MEMORANDUM

SUBJECT: Final Adoption of Water Quality Standards Regulation Amendments (9VAC25-260): Numeric Chlorophyll-a Criteria for the Tidal James River and their Assessment Methodology

DATE: May 16, 2019

Response to Technical Memorandum Cited by VAMWA to Recommend Upwards Adjustments to the Proposed Tidal Fresh Summer Mean Criteria

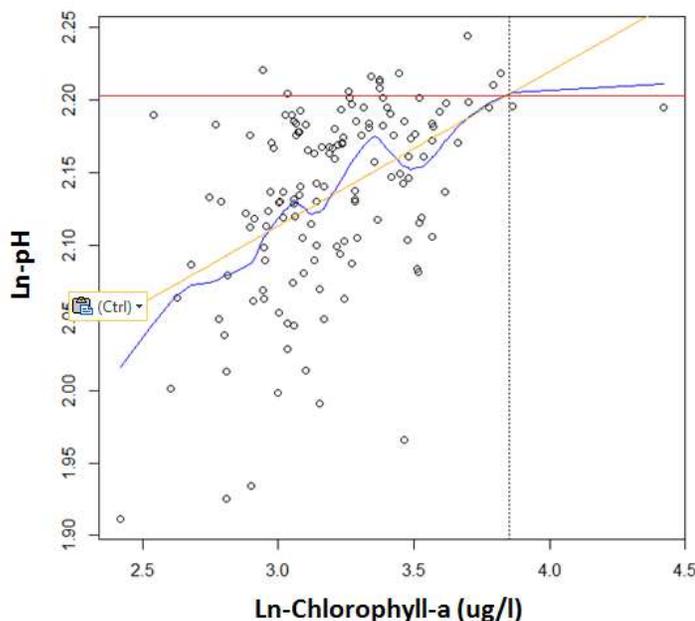
1. It is unclear whether Bell’s relationship is based on raw fluorescence (reported directly from the continuous monitor) or extracted chlorophyll-a equivalents as predicted from a calibration model. The chlorophyll-a data that were enclosed with his technical memorandum (hereafter referred to as the “Bell dataset”) were fluorescence values. The relationship used by DEQ to develop the proposed criteria was not based on raw fluorescence, but rather on estimates of extracted chlorophyll. To facilitate the consideration of Bell’s recommendation, the Bell dataset was “corrected” using the annualized correction factors developed by HRSD/VAMWA for the James River Chlorophyll-a Study and then aggregated into daily chlorophyll-a medians and daily 90th percentile pH values (Figure 1). The resulting scatterplot is not the same as the scatterplot that Bell presents in his technical memorandum and thus the resulting empirical models are different from his. Because observations that are known to be suspect are present in the Bell dataset and observations that VIMS and DEQ have deemed valid are missing for unknown reasons (see Footnote 1), the validity of any model derived from this dataset is questionable.

2. Bell does not provide measures of fit so that his simple linear regression and LOWESS models can be objectively compared. To verify his assertion that the LOWESS curve produces better predictions, LOWESS and simple linear regression models were fit to the corrected Bell dataset. The LOWESS curve does indeed fit better in terms of root mean square error (RMSE). The RMSE for the LOWESS model is 0.44 versus 0.46 standard unit for the simple linear regression model. However, the effect threshold predicted by both models is the same (47 $\mu\text{g/l}$). This is lower than the effect threshold used by DEQ to develop the proposed tidal fresh criteria.

- If the Bell dataset is to be considered valid, then its use should not just be restricted to developing an effect threshold for elevated pH. DEQ used the 2006-2008 continuous data not only for this purpose, but also to quantify temporal variability in the stretch of the tidal fresh between river miles 67 and 95. Using this dataset, DEQ estimated the upper 95% confidence limit of the summertime average chlorophyll-a standard deviation (log-normal) to be 0.396182296 µg/l. The corresponding estimate produced from the Bell dataset is 0.347734817509471 µg/l (see Table 1). Using this estimate of variability and the effect threshold of 47 µg/l, the proposed criteria for the tidal fresh segments would remain unchanged.
